Bellefonte Nuclear Plant, Units 3 & 4

COL Application

Technical Specifications

PLANT SPECIFIC TECHNICAL SPECIFICATIONS (PSTS)

Figure B 3.6.8-1 (page 1 of 1)
Time Prior to Coolant Inventory Boiling

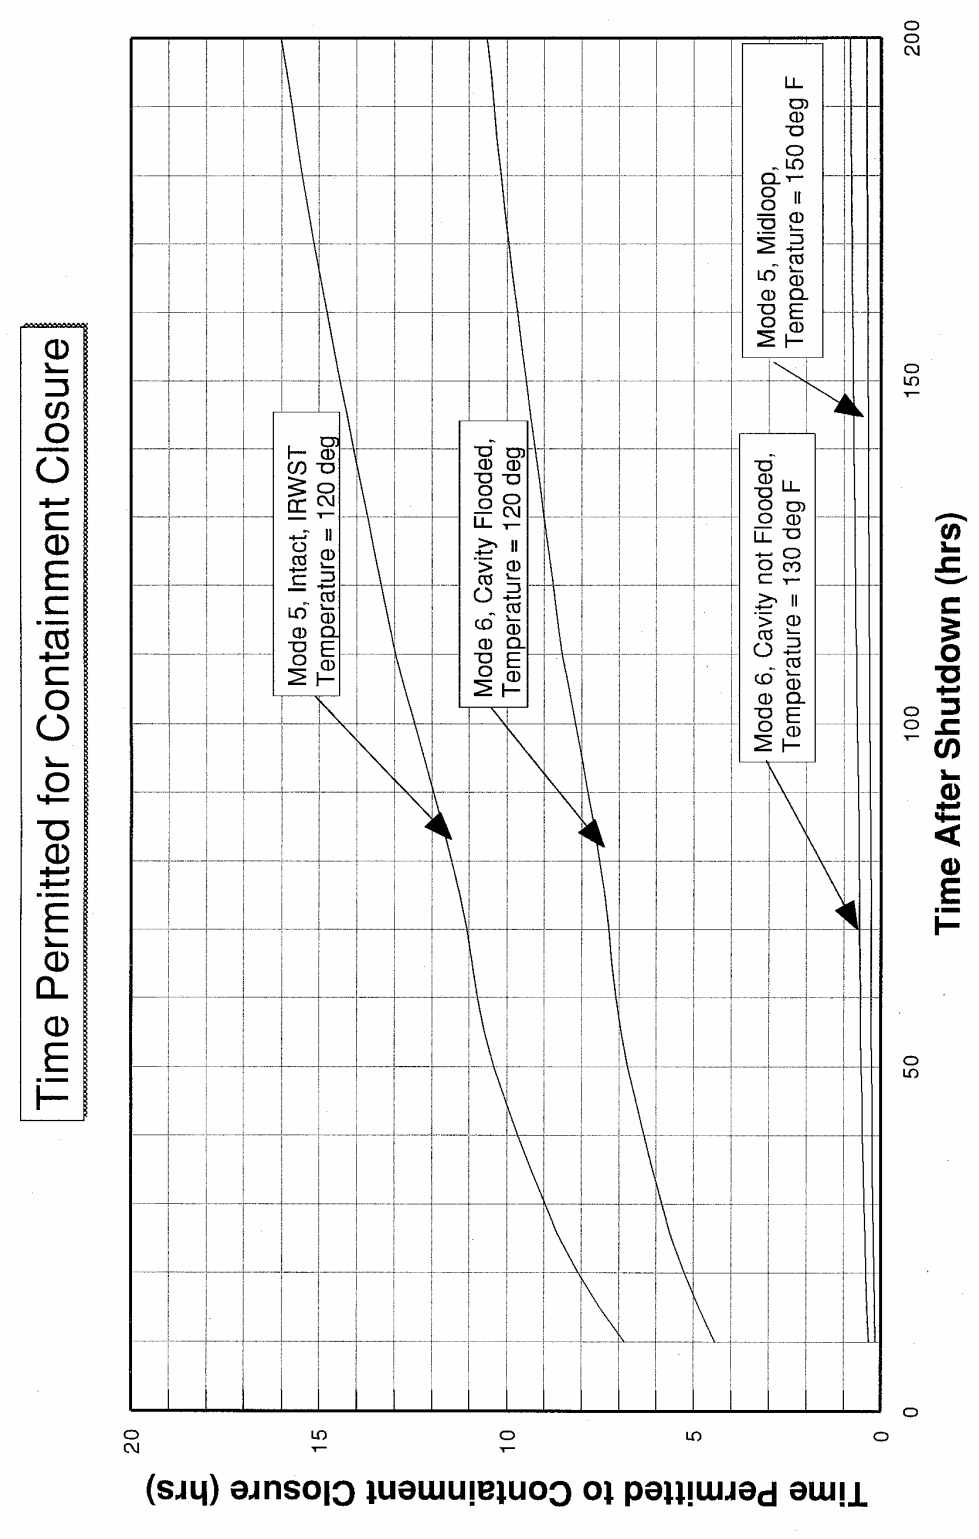
GTS 3.6.8 Bases Figure B3.6.8-1 contains a bracketed curve identifying the time permitted for containment closure in terms of time after shutdown. The entire figure is bracketed. The plant specific curve needed to replace the bracketed value is determined from final fuel data. Therefore, a Bases change is required to provide a plant specific set of curves to replace the bracketed figure. This Bases change will be completed prior to initial fuel load.

FIGURE 4.1-1 Low Population Zone and Site Boundary Map

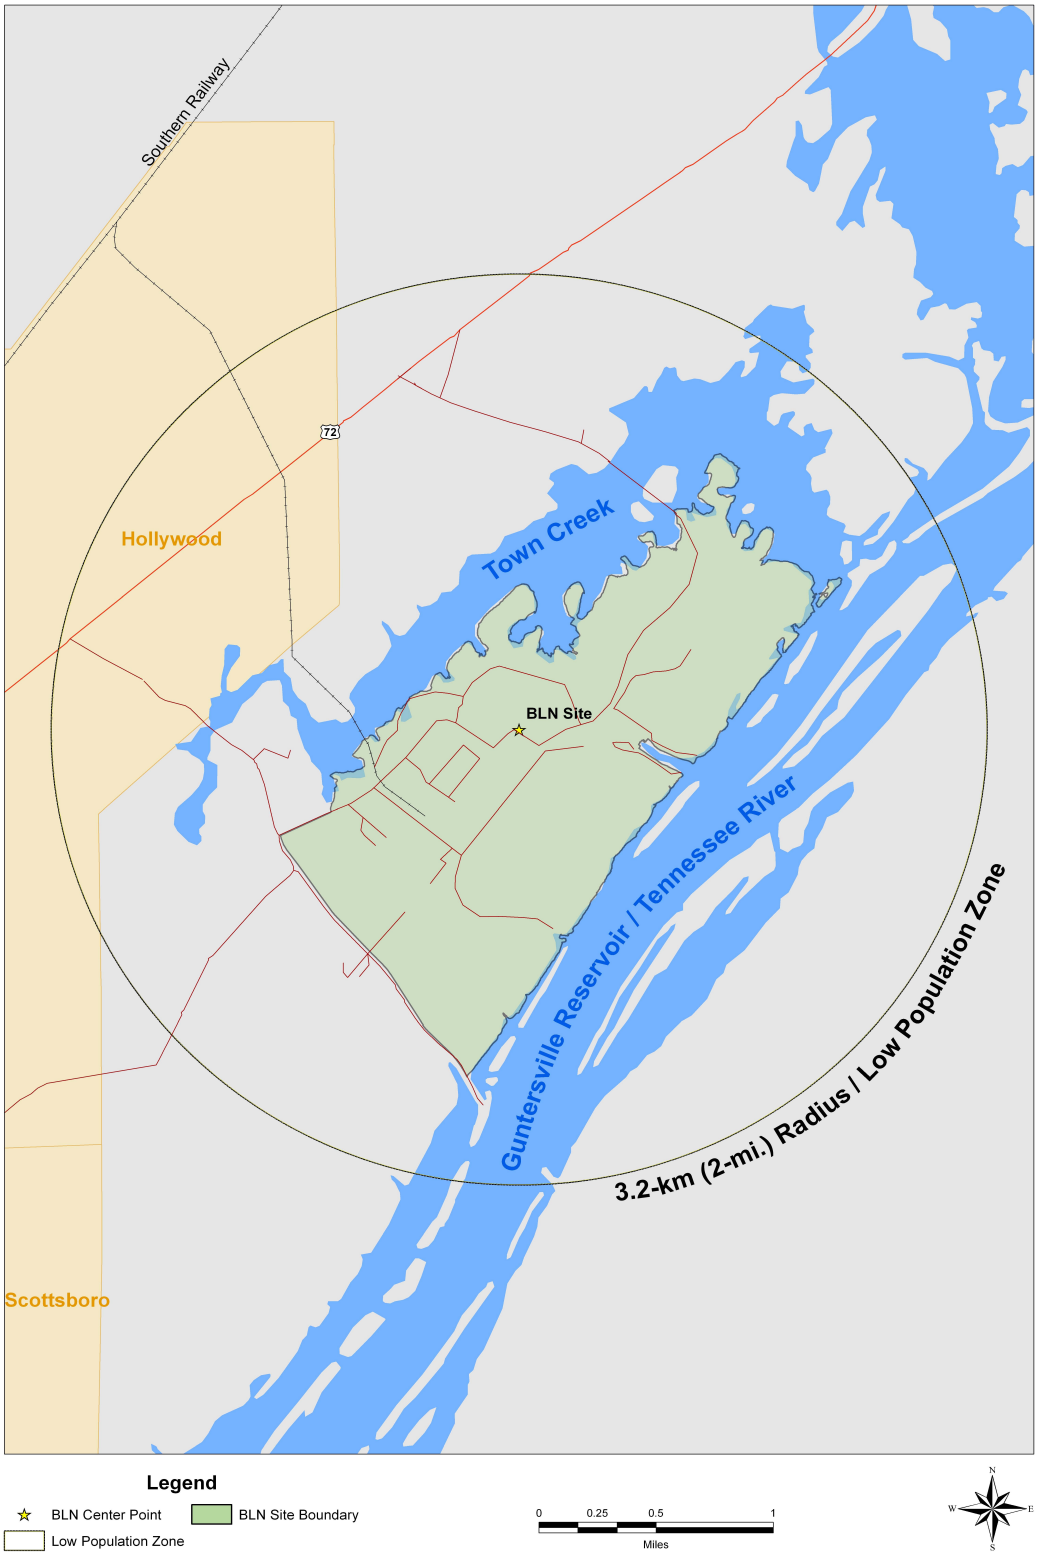
Replace the bracketed information in the GTS with the following:
The Site Boundary is shown in Figure 4.1-1. The Exclusion Area Boundary is shown in Figure 4.1-2.

Replace the bracketed information in the GTS with the following:
The LPZ is defined by the 2 mile radius from the site center point as shown in Figure 4.1-1.
